Re: ACTION RE: PETITION FROM FOX TRAIL DEVELOPMENT, LLC. REQUESTING SITE PLAN AND DESIGN REVIEW FOR THE CONSTRUCTION OF A SINGLE-TENANT OFFICE BUILDING LOCATED AT 2110 & 2120 RIVERSIDE DRIVE, PARCELS AL-63 & AL-64 (current vacant lot)

Site Plan & Design Review – Staff Comments (reviewed 12-16-2023)

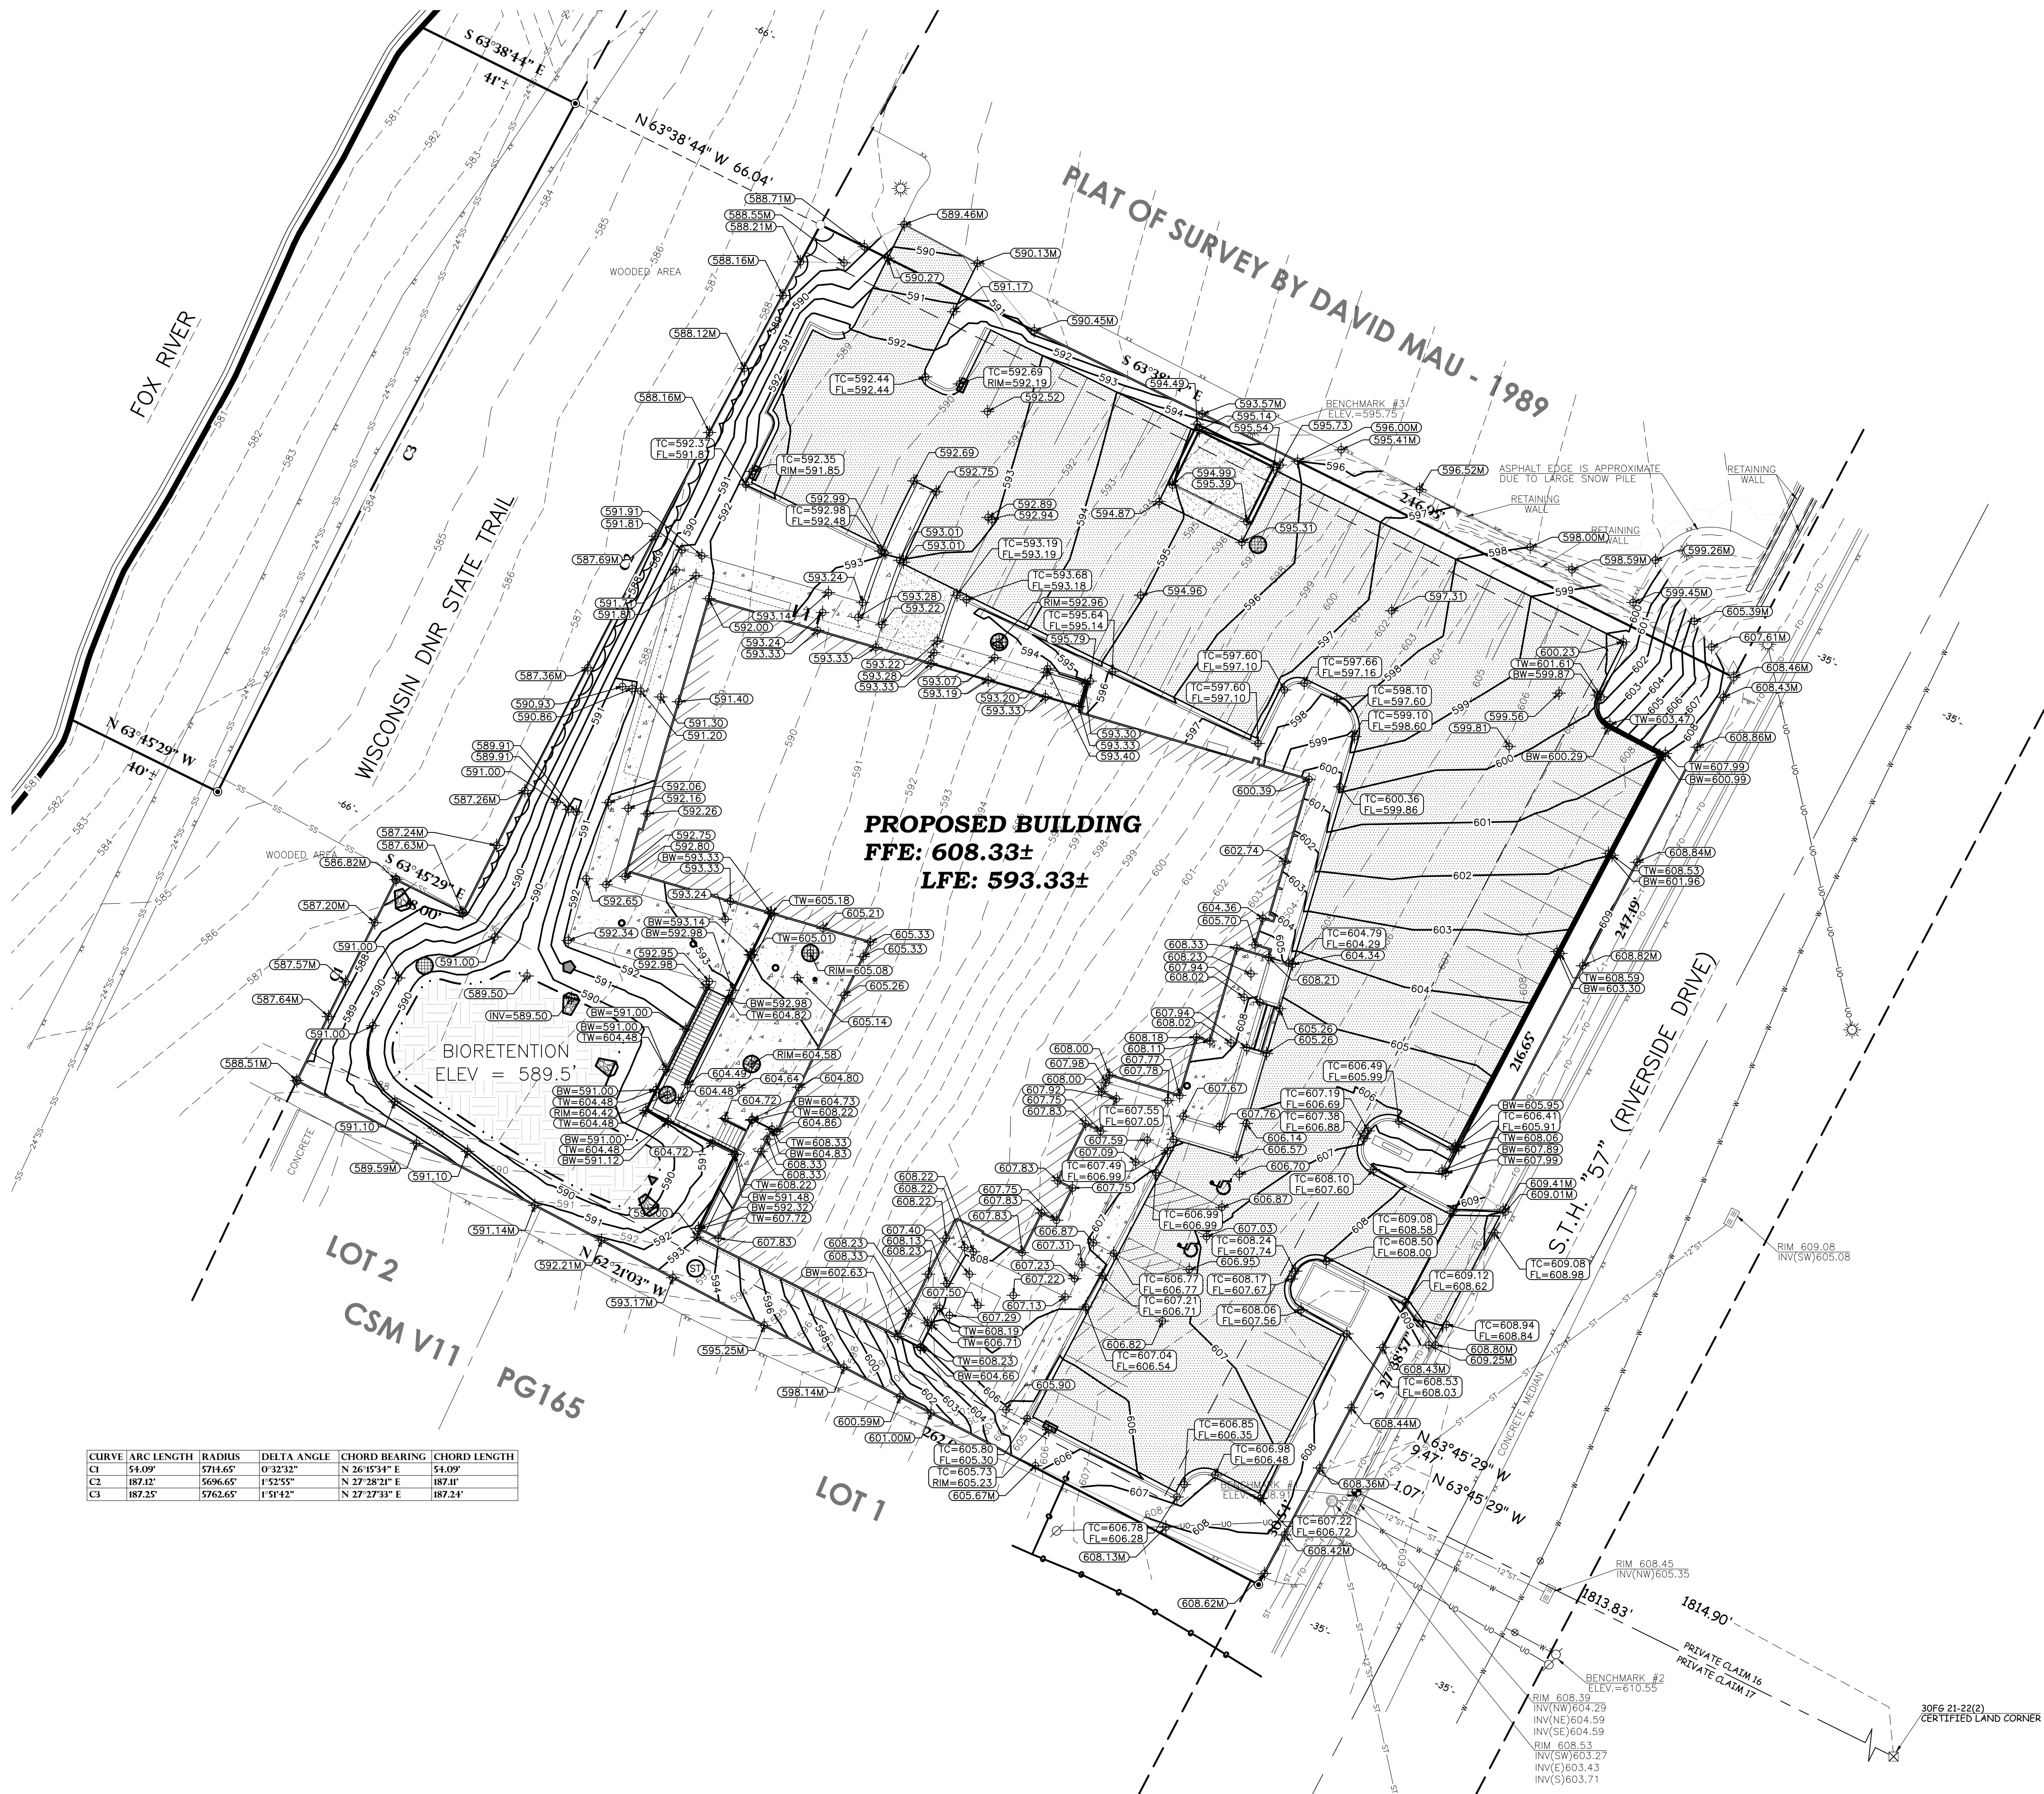
- Zoning Section 475-802:
 - Minimum of seven short-term bicycle parking spaces should be provided.
- Zoning Section 475-807:
 - Driveways should be constructed of concrete not less than six inches in depth with curbs on both sides running from property line to street curb.

- Zoning Section 475-903F:
 - Landscape shrubs should be moved back two feet or a vehicle bumper used where retaining wall does not impede vehicle overhang in landscaping or sidewalk.

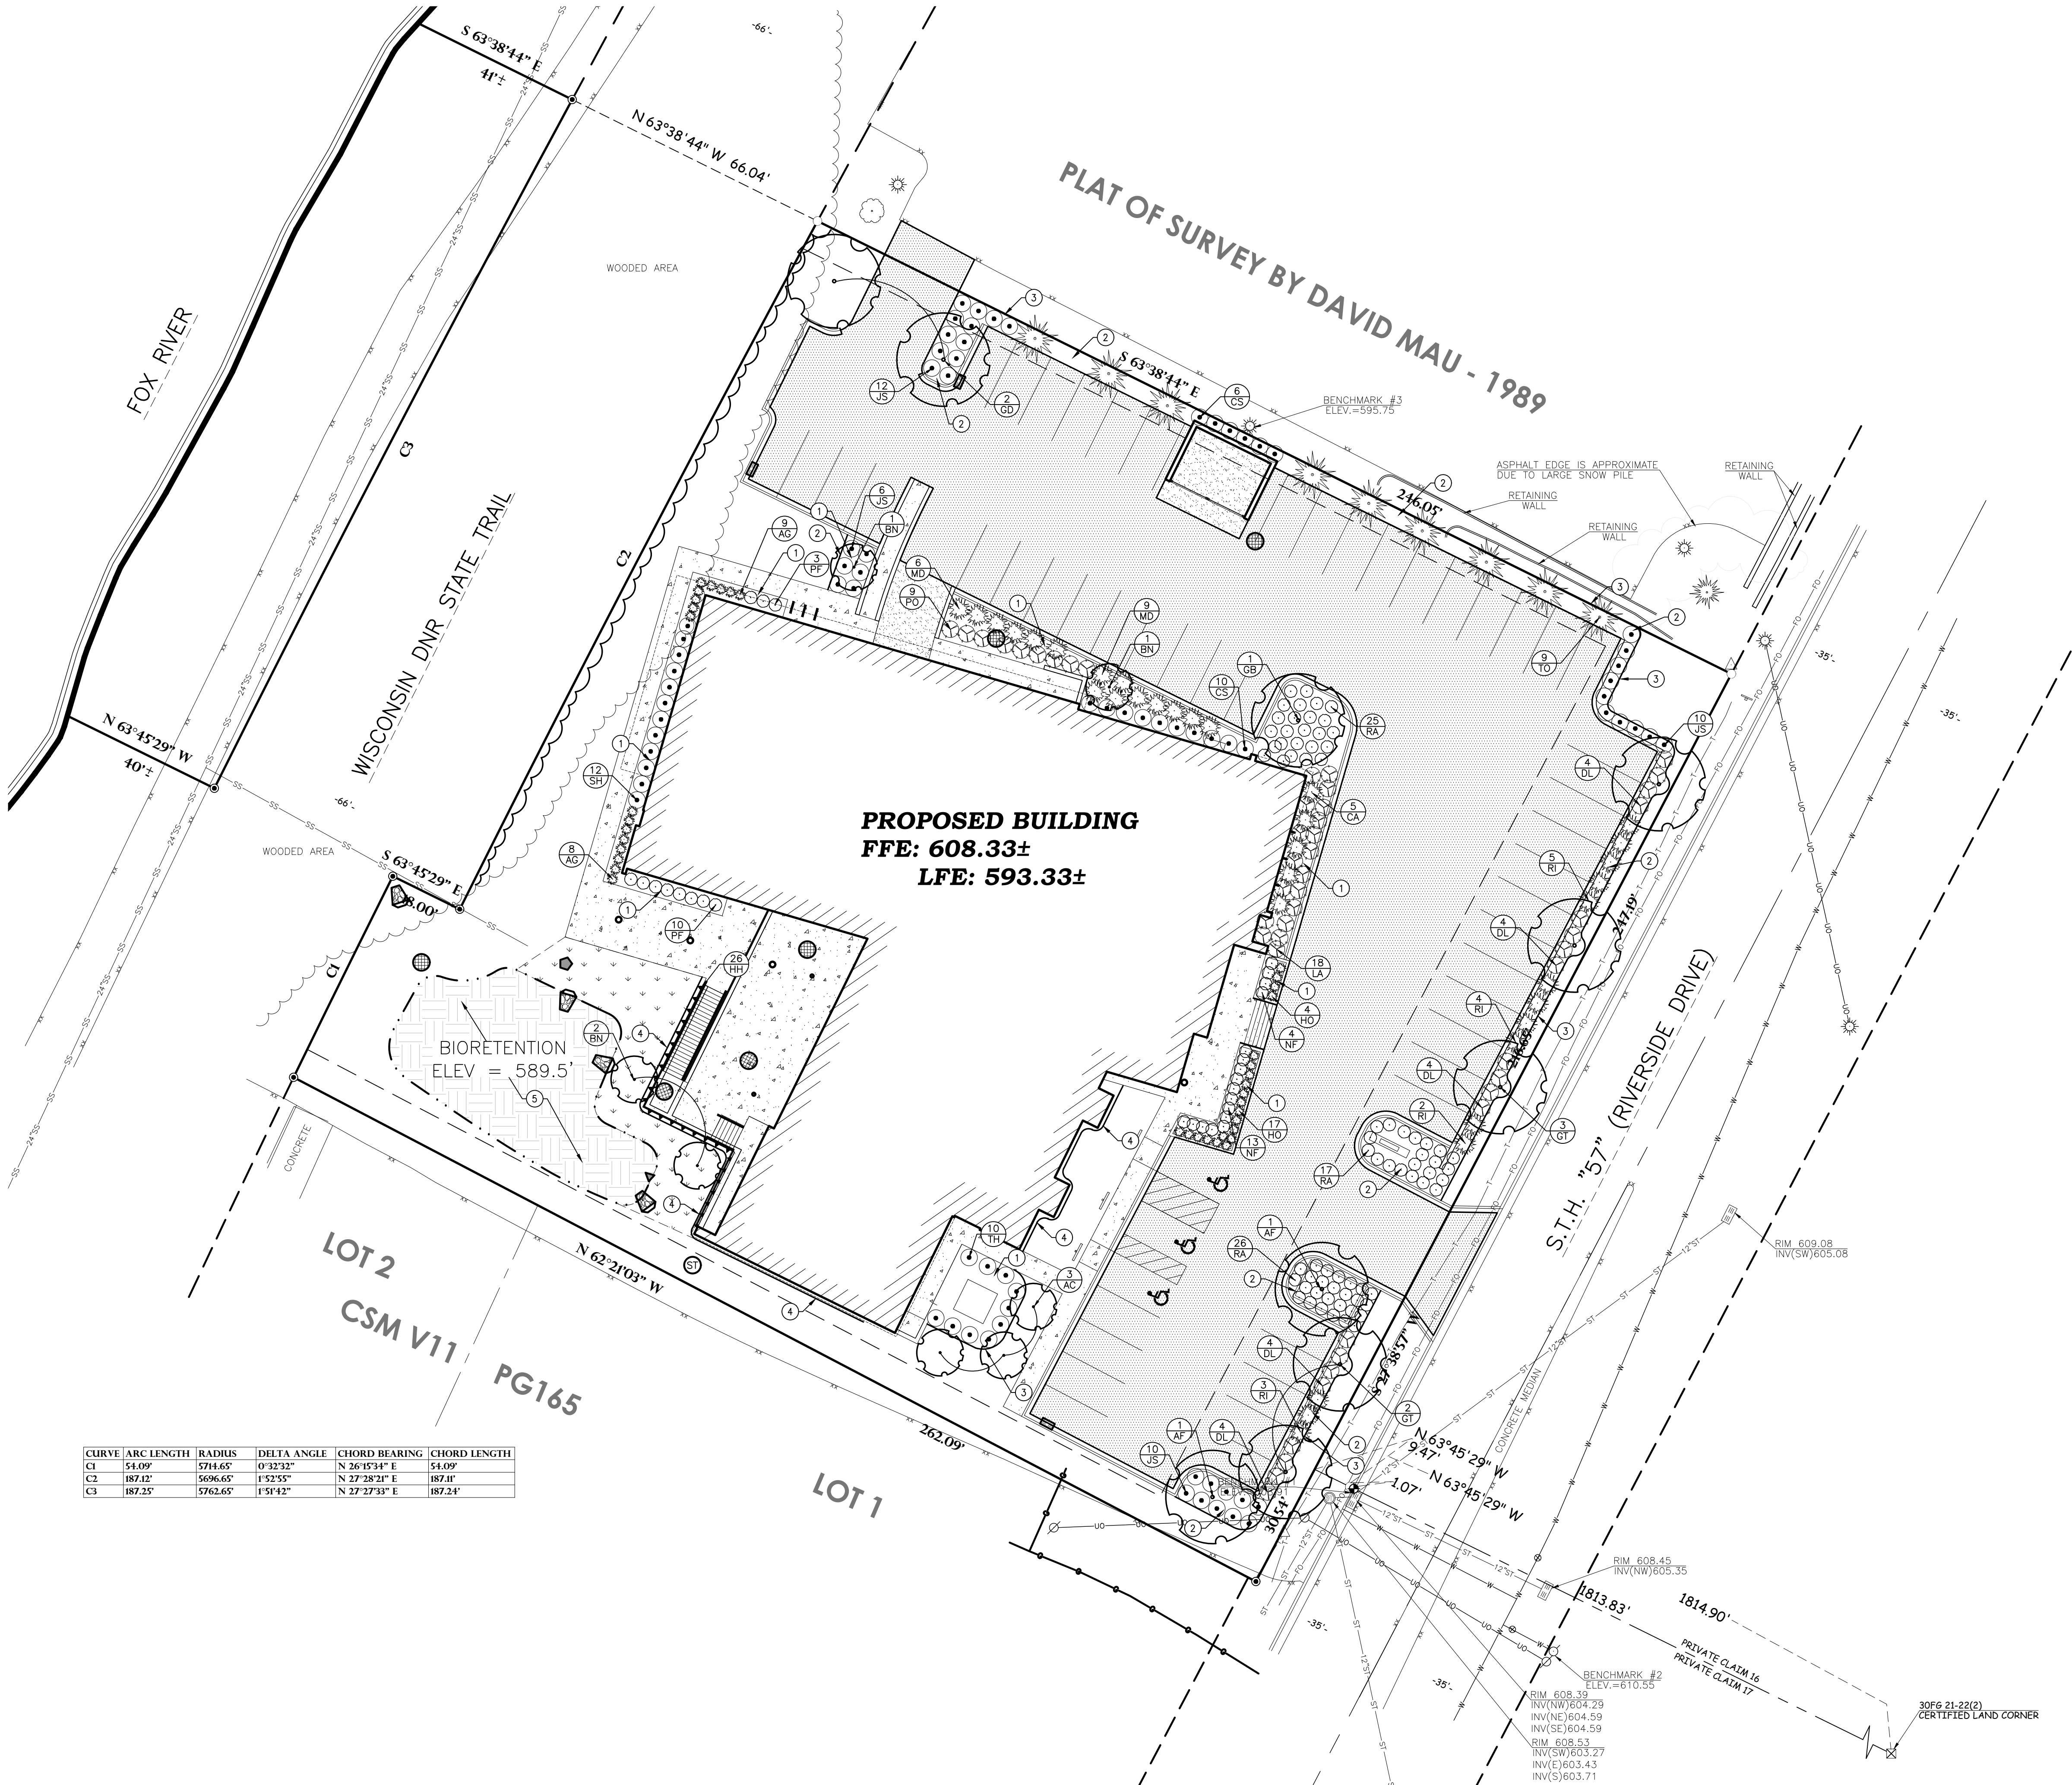
- Zoning Section 475-302K:
 - Additional building specifications for refuse storage enclosure requested.
 - Landscaping required on three sides of the refuse enclosure.

ELECTRICAL -
SITE - PHOTOMETRIC LIGHTING PLAN
SCALE: 1" = 10'-0"

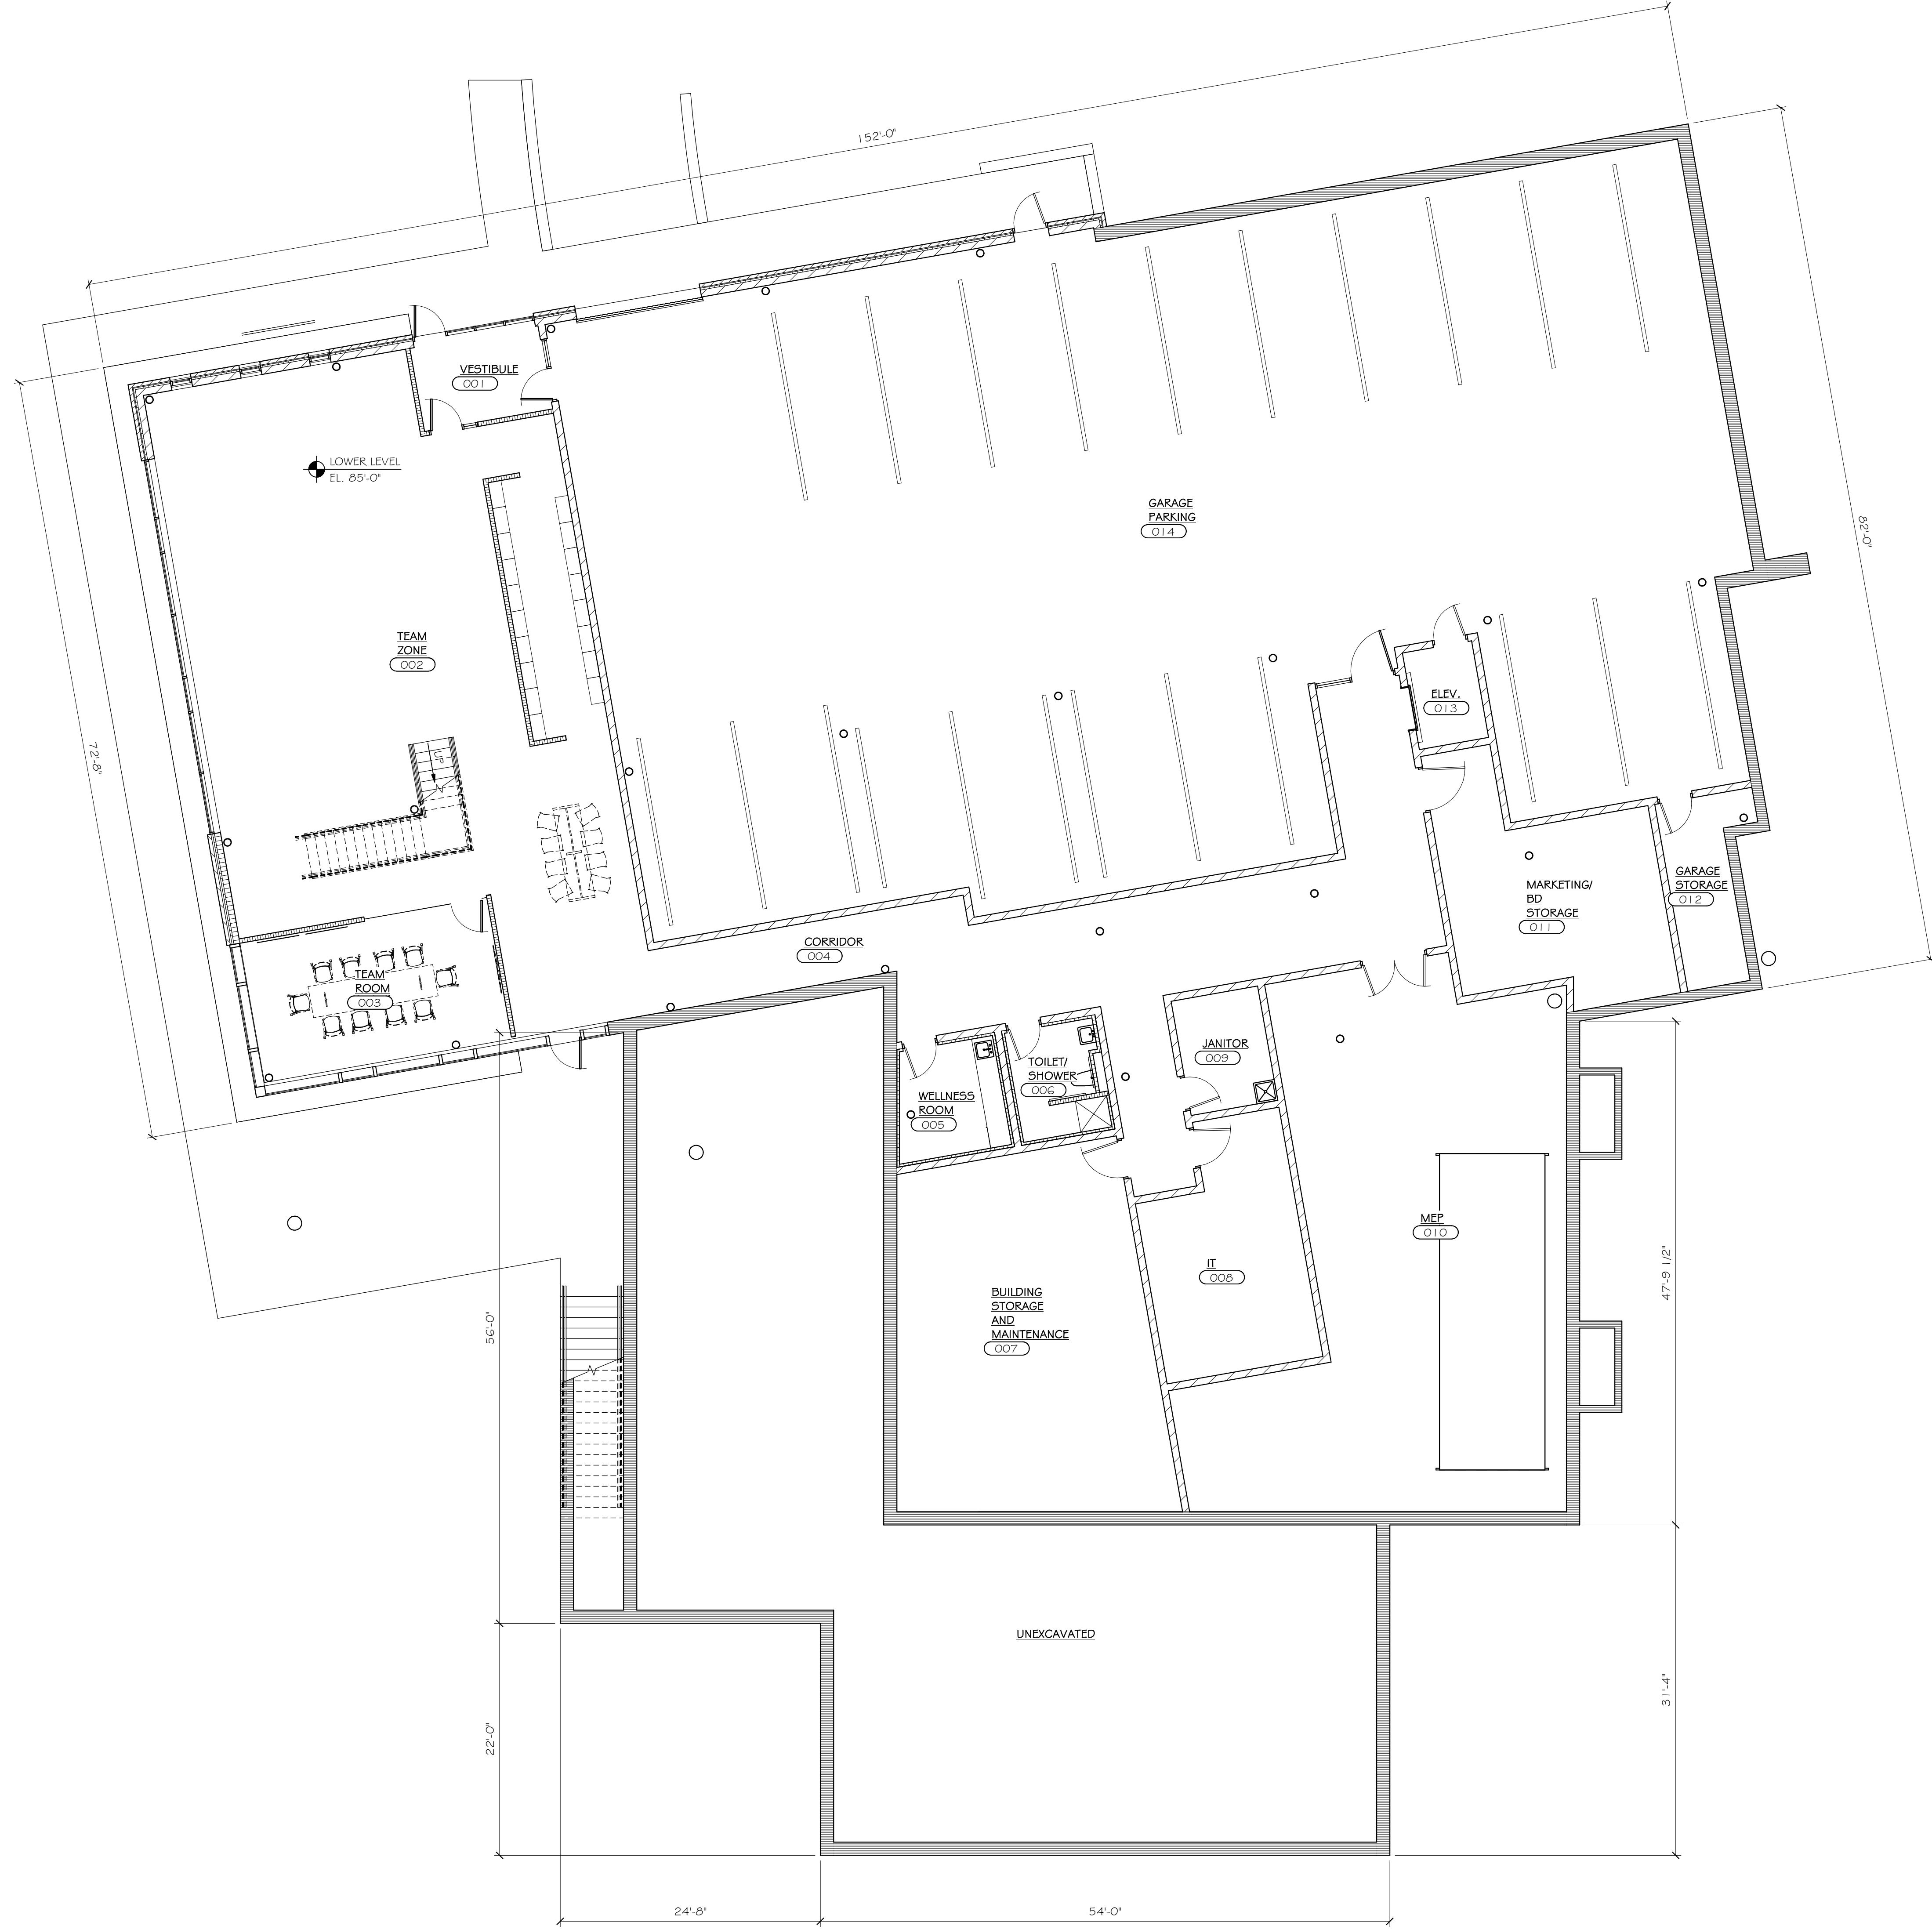
- Zoning Section 475-904:
 - Parking lot lights meet requirements. Additional information requested if other site lighting is requested.
- Zoning Article X – Signs:
